**Subject: Palo Verde Nuclear Generating Station (PVNGS)
Units 1, 2, and 3 and Independent Spent Fuel Storage
Installation
Docket Nos. 50-528, 50-529, 50-530 and 72-44
License Nos. NPF-41, NPF-51 and NPF-74
PVNGS Emergency Plan, Revision 64**

PVNGS Emergency Plan, Revision 64

Description of Changes

FIGURE 7 STATE, COUNTY & LOCAL EMERGENCY OPERATIONS CENTER ORGANIZATION

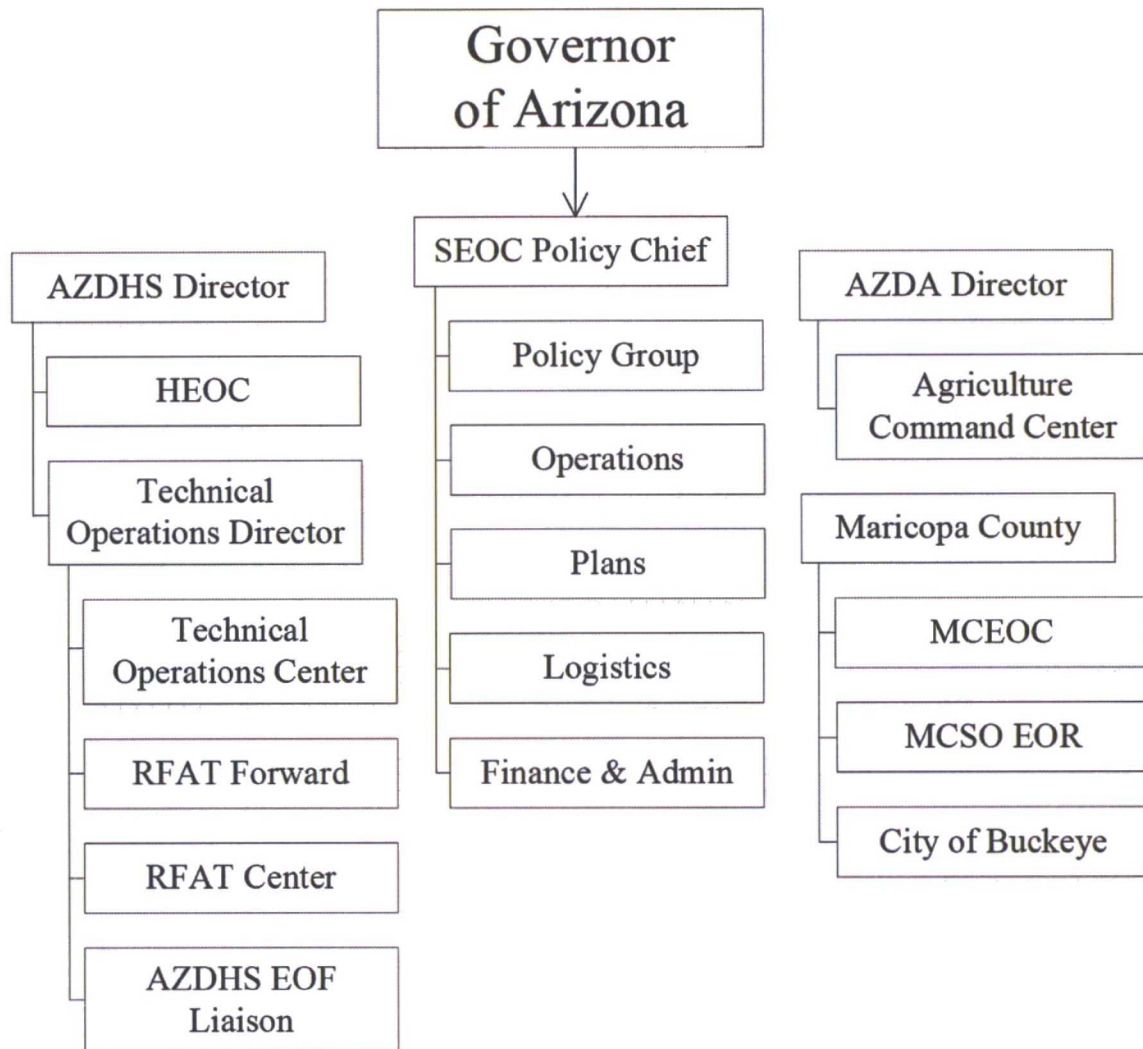
48, Figure 7	Updated Figure 7 to reflect new reporting structure.
56, Step 6.7.1.1	Changed onsite protective of employees to "Onsite protection of employees..." for better readability
71, Step 7.2	Corrected bulleted column breaks so they read 1) Radiological Assessment Coordinator 2) Radiological Assessment Coordinator.
71, Step 7.2.2	Changed to "The Environmental Assessment Line has a dedicated primary and backup line providing communications links with conference capability between the TSC, EOF, the Control Room and the RSP.
72, Step 7.2.7	Changed to "The Radiological Line has a dedicated primary line providing communications links with conference capability between the RP Office, TSC, Control Room, STSC, the OSC, and the RSP.
75, Step 7.2.28	Changed to "Water Resources."
74, 75, 77, 78, 103	Changed ADEM to DEMA here and throughout the document
82, Step 7.3.1.8	Changed section title from Portable Survey Instruments to "Qualified Safety Parameter Display System (QSPDS)"

Current Revision	Organization chart led by policy Group – Governor Chairman, Maricopa County Board of Supervisors Director ADEM AZ Homeland Security
Change Page 48, Figure 7	Organization chart led by Governor of Arizona
EP Function	10 CFR 50.47(b)(3)
Effectiveness Review/Conclusion	This change is not a reduction in effectiveness of the Palo Verde Emergency Plan because it consolidates and minimizes confusion of the organization under the Governor of Arizona. The change has no impact on the associated planning standard or EP Function.
Change Summary	Changed the word from “protective” to “protection” for clarity
Current Revision	Onsite protective of employees during a hostile action involves a combination of restricted movement, movement to safe locations, and site evacuation depending on the nature of the hostile event and advance warning.
Change Page 56, Step 6.7.1.1	Onsite protection of employees during a hostile action involves a combination of restricted movement, movement to safe locations, and site evacuation depending on the nature of the hostile event and advance warning.

**FIGURE 12 DEMOGRAPHY WITHIN THE PLUME EXPOSURE PATHWAY
EMERGENCY PLANNING ZONE**

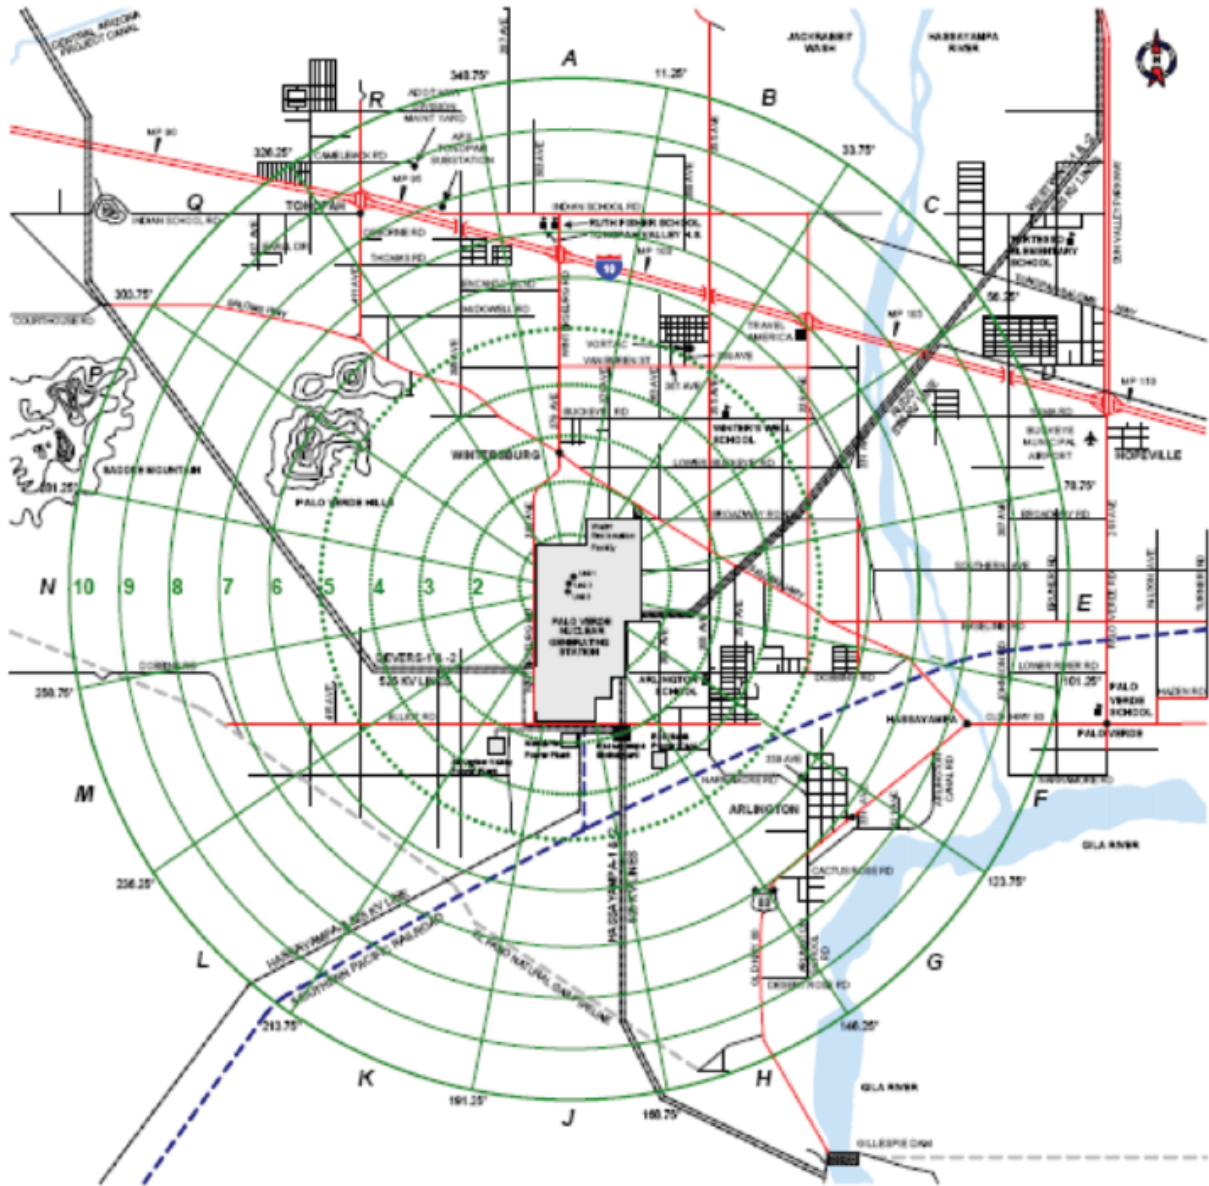
EP Function	10 CFR 50.47(b)(3)
Effectiveness Review/Conclusion	This change is not a reduction in effectiveness of the Palo Verde Emergency Plan.
Change Summary	Updated October 2017 data within the Demography Within the Plume Exposure Pathway Emergency Planning Zone chart to current November 2018 data
Current Revision	Palo Verde Population Survey – October 2017
Change Page 107, Figure 12	Palo Verde Population Survey – November 2018
EP Function	10 CFR 50.47(b)(10)
Effectiveness Review/Conclusion	This change is not a reduction in effectiveness of the Palo Verde Emergency Plan because it adds the most current demography numbers.
Change Summary	Cross reference to NUREG 0654 Section 16 updated
